**SHA** STATE OF MARYLAND  
DEPARTMENT OF TRANSPORTATION  
STATE HIGHWAY ADMINISTRATION  
OFFICE OF TRAFFIC & SAFETY  
TRAFFIC ENGINEERING DESIGN DIVISION  
MD 30 RELOCATED  
FROM SOUTH OF WOLF HILL DRIVE TO NORTH OF HAMPSTEAD  
NORTH TIE-IN HIB INSTALLATION

4/01/08 - FIELD CHANGE

**TRAFFIC SIGNALIZATION PLAN**

TS NO. 4612 DRAWING SG-05 OF 19 SHEET NO. 17 OF 82

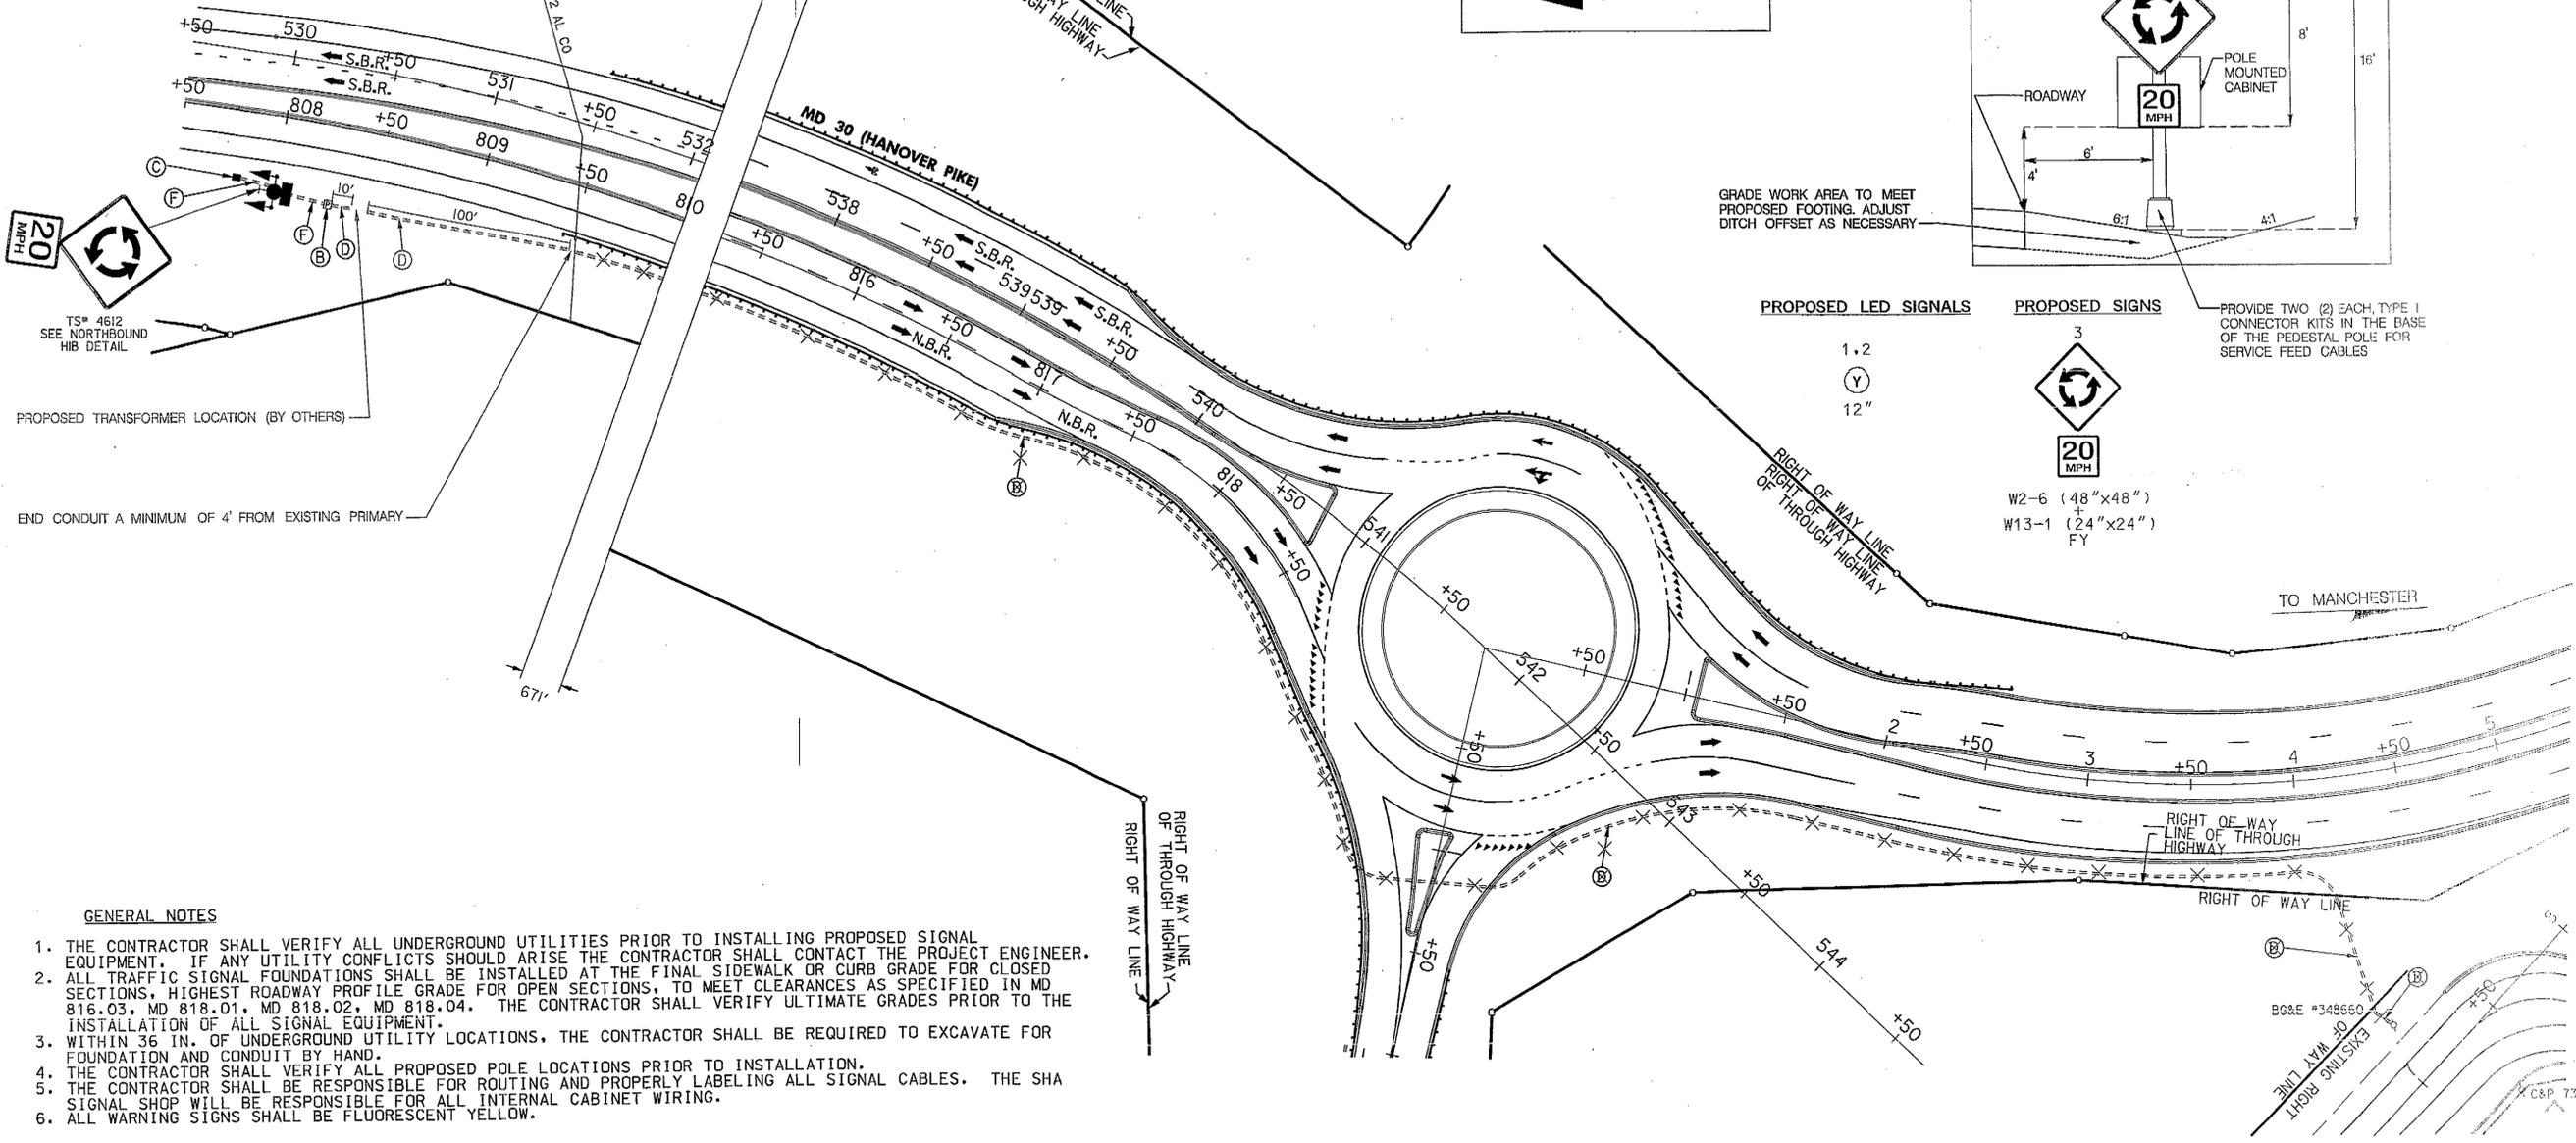
GRADE WORK AREA TO MEET PROPOSED FOOTING. ADJUST DITCH OFFSET AS NECESSARY

PROVIDE TWO (2) EACH, TYPE I CONNECTOR KITS IN THE BASE OF THE PEDESTAL POLE FOR SERVICE FEED CABLES
